RICHARD L. MEEHAN

To: IDI (Inclusive Development International), Asheville, North Carolina, USA

Re: Dairi Prima Minerals (DPM) Mine site risks and Tailings disposal safety.

Figure 2. View of author's estimate of tailings

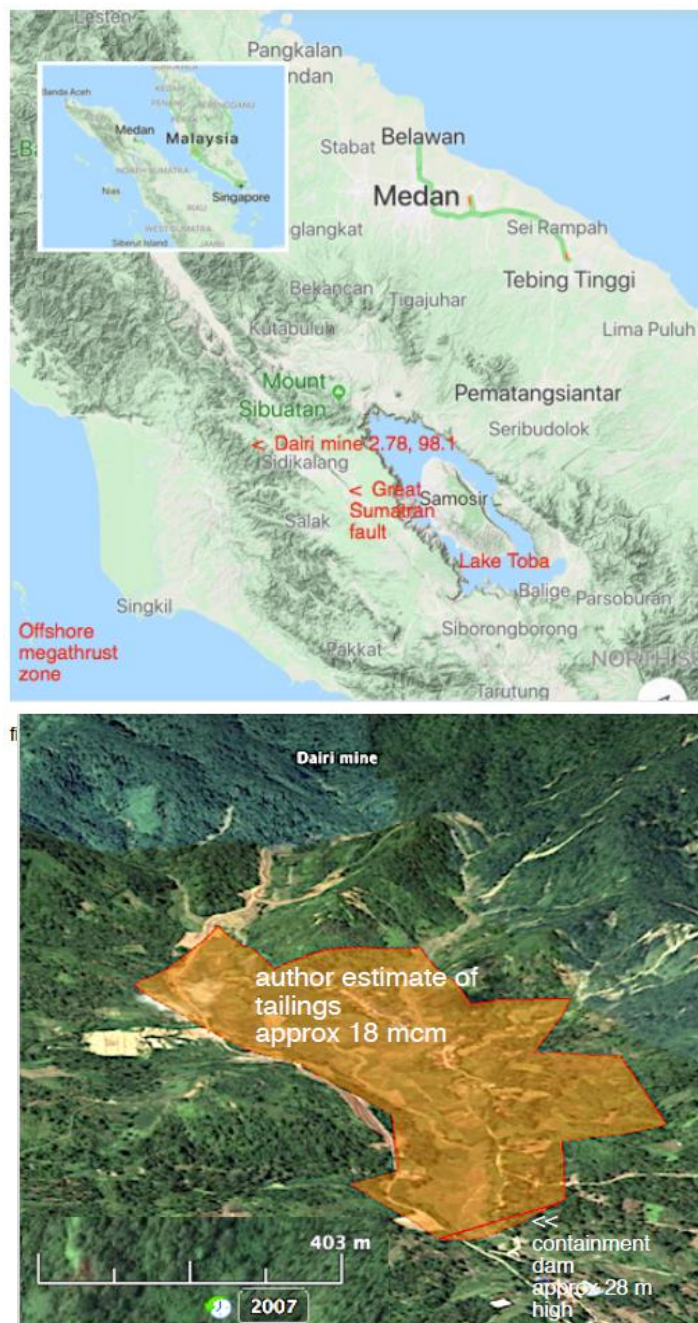
For the current 30 mt plan, I estimate the volume of above-ground storage for the waste slurry would be on the order of 10 mcm. Additional volume would be required to hold stormwater and landslide debris (see below) and whatever freeboard (reserve storage) is required for safety. Altogether my working estimate for full capacity of the storage facility is about 18 mcm. If this is correct, that would require a tailings facility as shown in figure 2. Note that this estimate assumes complete success in the paste backfill plan, which as yet has not been demonstrated in terms of economics (millions of tons of expensive cement will be needed), technical aspects (a successful recipe has not been shown) or safety (the paste backfill could increase the possibility of toxic chemical leakage from the abandoned mine into the environment).

Figure 3. Historical earthquake (Hayes, et al., 2013)

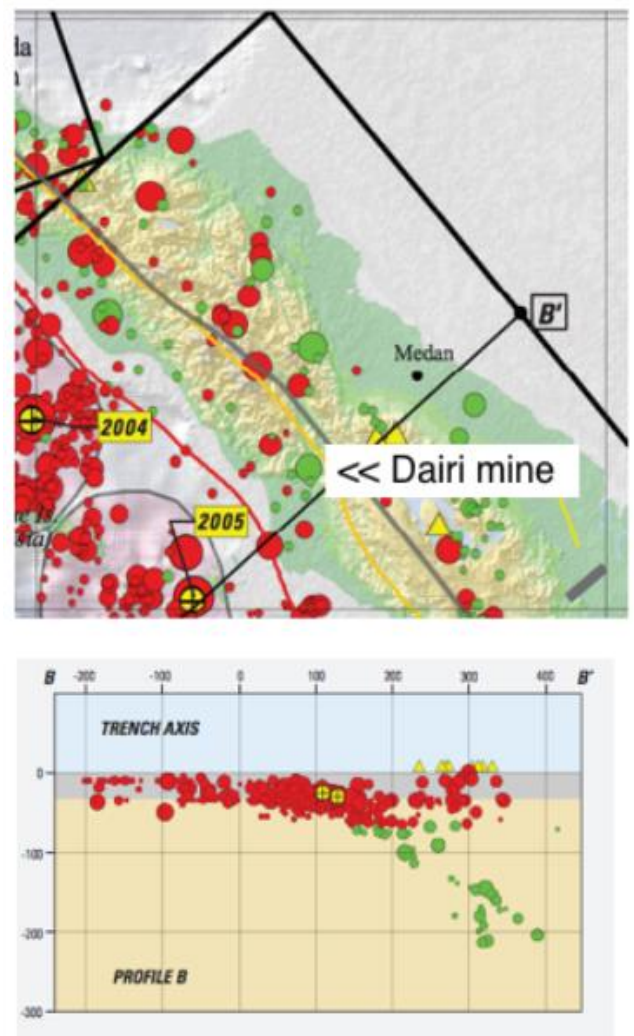
The mine is located in one of the world's most active earthquake regions, along the Sumatra subduction megathrust apparently near a triple plate junction which produced in 2004 and 2005 earthquakes of magnitude 9 and 8+ respectively (fig 3). These events rocked buildings as far away as Bangkok and produced intense regional damage including to road embankments and bridge abutments, which are similar in their behavior to tailings dams. Intensity of ground motion produced destruction of facilities at Banda Aceh, which is a comparable distance from the earthquake to the Dairi mine. Japanese investigators (see Sorenson et al., 2007) found that damage was up to about level 6, Japanese JMA scale. This damage category (6.0-6.4) produces these effects:

A map and cross section showing historical earthquakes is extracted from a comprehensive summary of seismicity of the area published by the US Geological Survey (Hayes, et al., 2013). This map and many other publications provide comprehensive information on regional seismicity sufficient to evaluate earthquake risk.

figure 5. Tailings dam very close to Sumatra fault with likely earthquakes up to M 7.5-7.9 and ground accelerations of 100%g

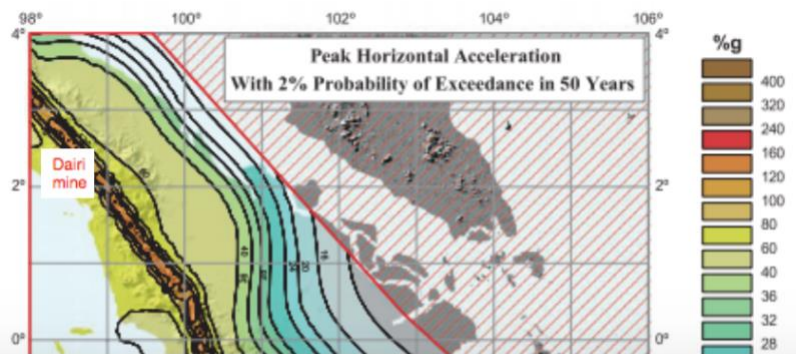
Although the offshore subduction zone mega earthquake poses a threat to long-period structures like tailings deposits, a more dangerous type of earthquake can be expected from the Great Sumatra fault which breaks ground only 15 km to the east of the Dairi site. According to Peterson et al (Ref Petersen et al., 2004) and others this fault is capable of generating earthquakes up to magnitude 7.5 to 7.9 and at this close distance are likely to produce very high ground accelerations on the order of 50-100% gravity (Figure 5).

Earthquakes of magnitude 6 to 7 are routine on and near the Great Sumatran Fault and will certainly occur during the mining phase and cause at least some damage to the facility even under the best of conditions -- a robust dry dam built on a strong rock foundation. If the dam and particularly the foundation fall short of this ideal (most likely) the damage will be severe and may lead to a breach. More likely is a foundation consisting of variable volcanic ash and other deposits discussed above that will not provide sound support for the dam.

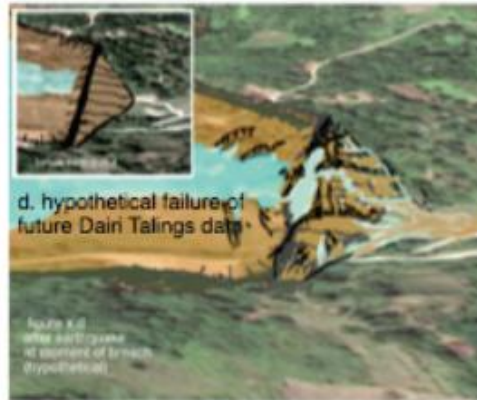
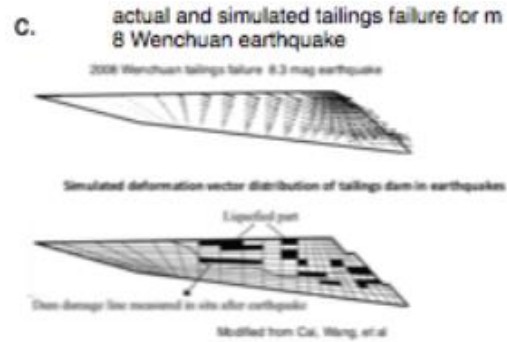
Failure of the containment for wet tailings would be most dangerous in the wet season with an abundance of water added to the containment. Cracking and sliding of the retaining structure would initially take on the appearance of the partial failure of the San Fernando dam, figure 6b (Castro et al 2003). But the San Fernando dam was subjected to only a few seconds of strong shaking. Larger earthquake from m 7.5 to 9 would produce shaking that would be much longer in duration with cracks and sliding of many meters in even robustly built dams. This would open the embankment to through flow of water and wet tailings, which would breach the Dairi containment (as in the Baldwin Hills Reservoir shown on video at <https://www.youtube.com/watch?v=c4sm7DdIMkk>) and also the Brazilian Brumadinho Mine.
